**Block 6 - Hotel**

## Proximity of buildings - street hierarchy

Proposed second floor plan of Buildings 5 and 6

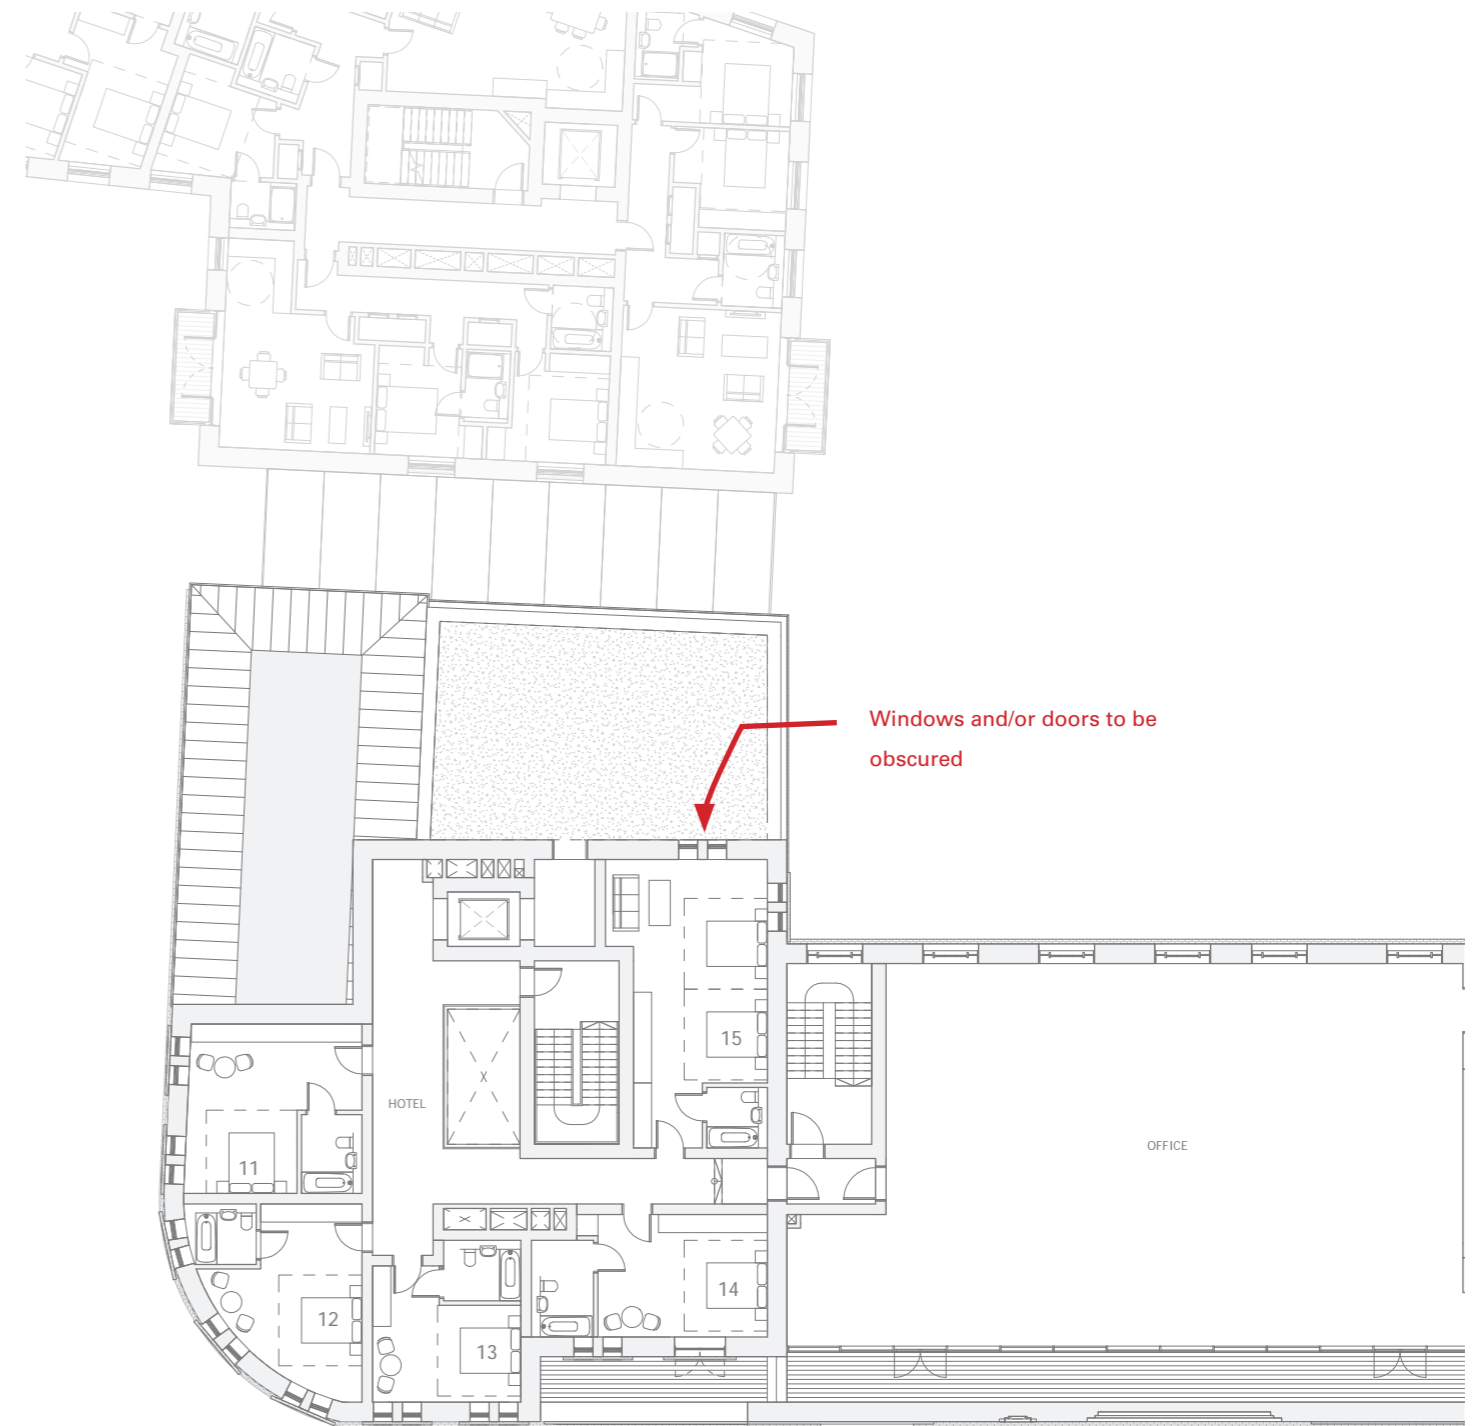
13. Block 6 and Block 5: only 4m gap between flat and wall. Unacceptable.

The 4 metre gap between the buildings is sufficient to clearly separate and distinguish the massing of Building 6 from the hotel building. The only windows that overlook from Building 5 towards Building 6 are to the set back elevation at second floor level of the hotel – we will be amending the elevation to either omit or obscure the hotel windows that face Building 6.

Proposed typical floor plan of Buildings 6, 7 and 8 - suggested mitigation

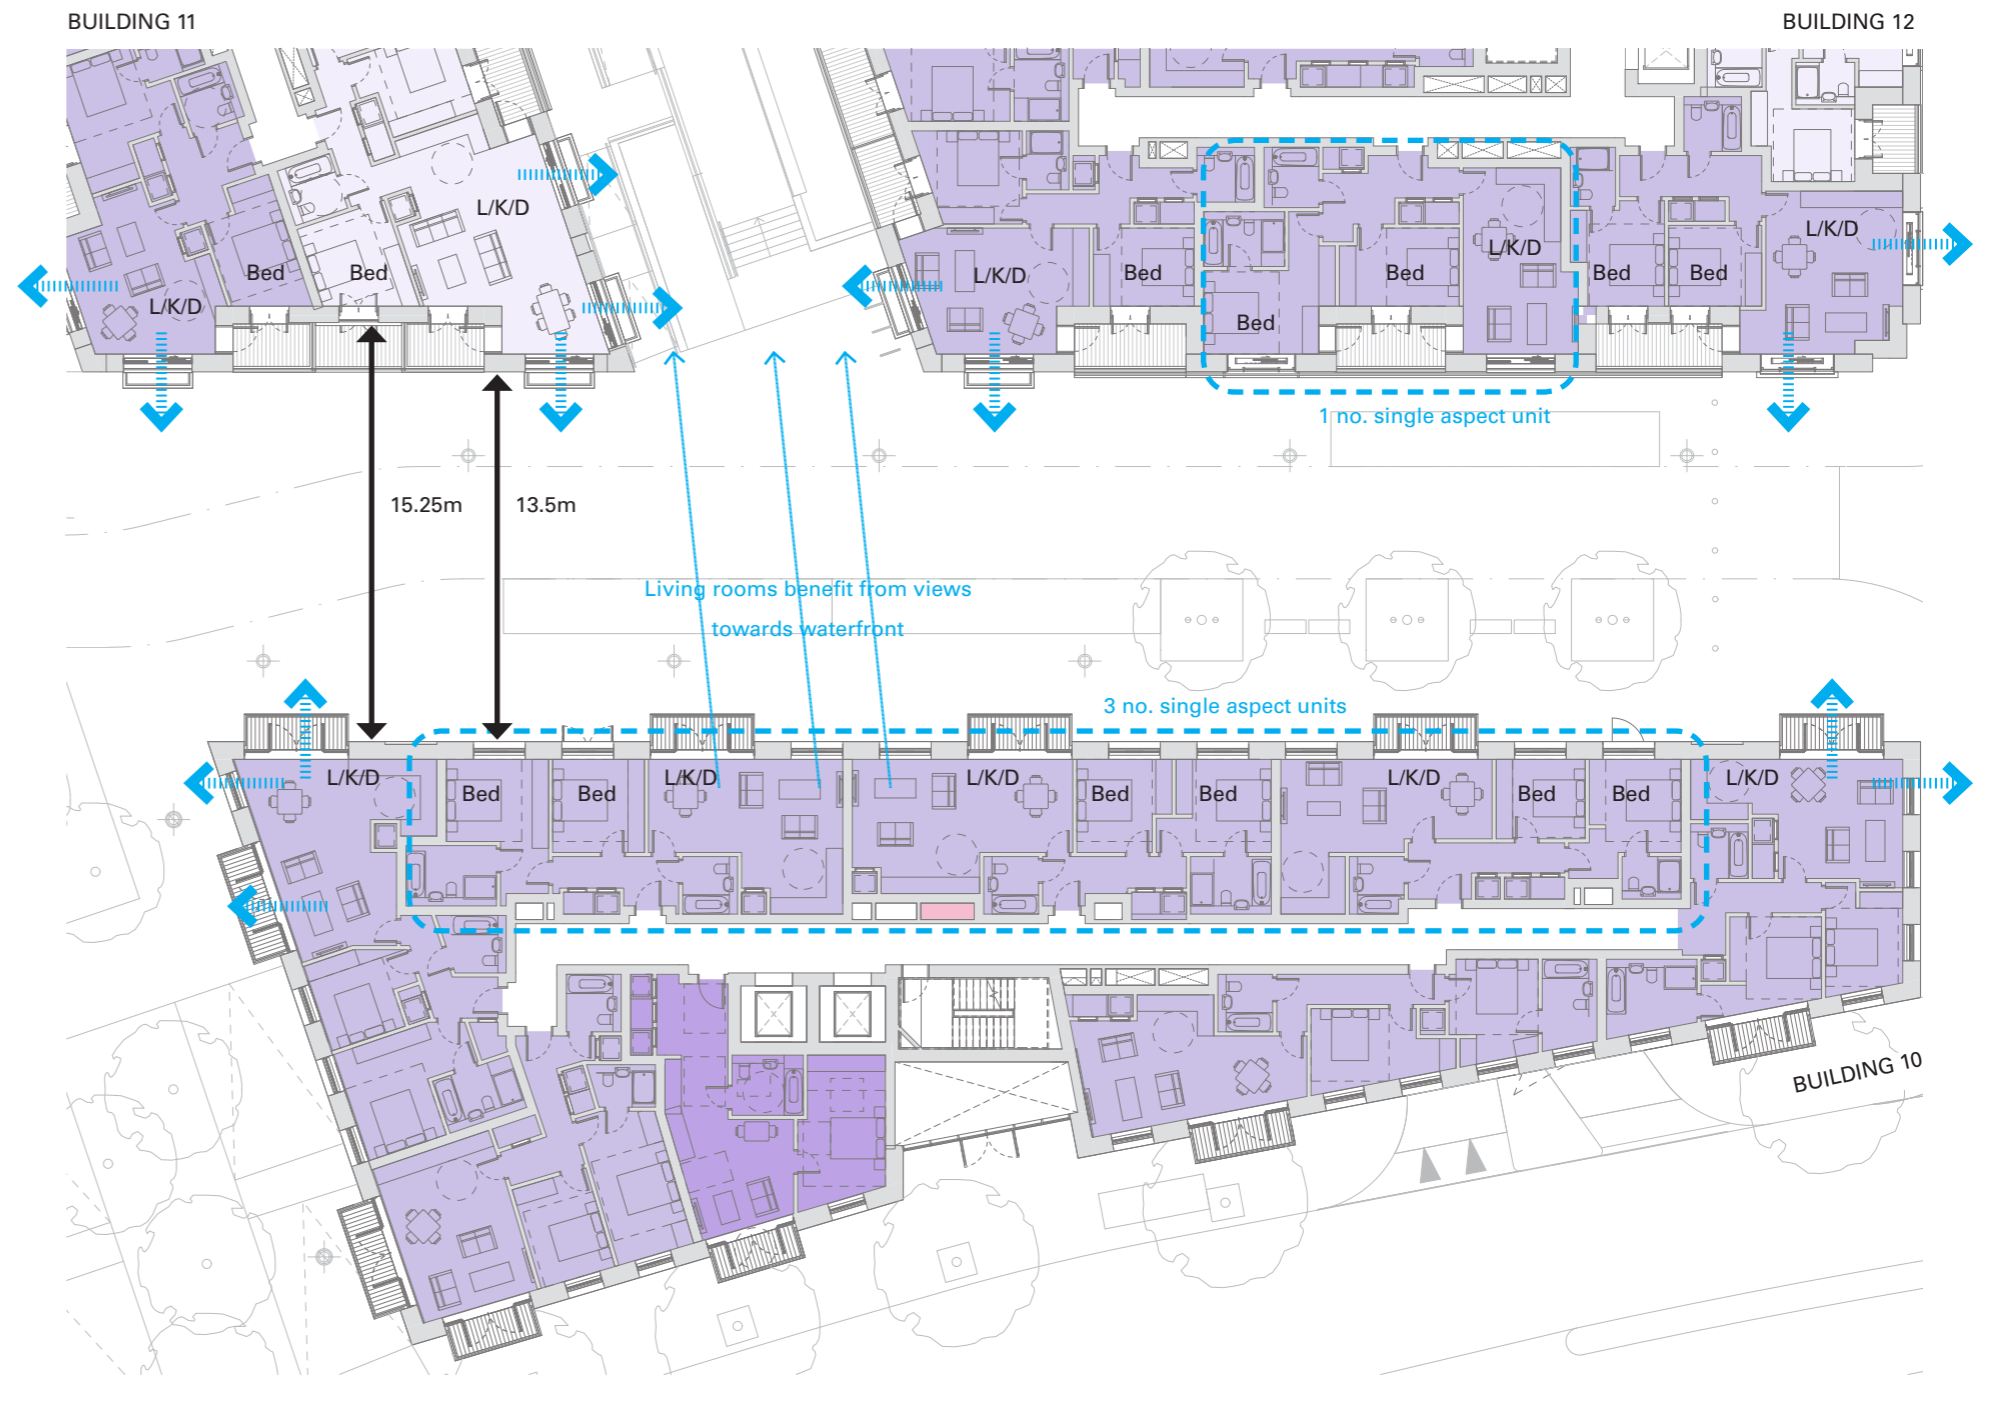
14. Block 6 with 7 and 8: only 16m gap. Unacceptable living conditions.

- All facing units are dual aspect
- Living/ kitchen/ dining rooms in B6 have been located so that they benefit from view towards waterfront
- Residential units face each other at 1st, 2nd and 3rd floor level only – above this B7 and B8 units benefit from views to South
- By obscuring glazing, overlooking is entirely mitigated
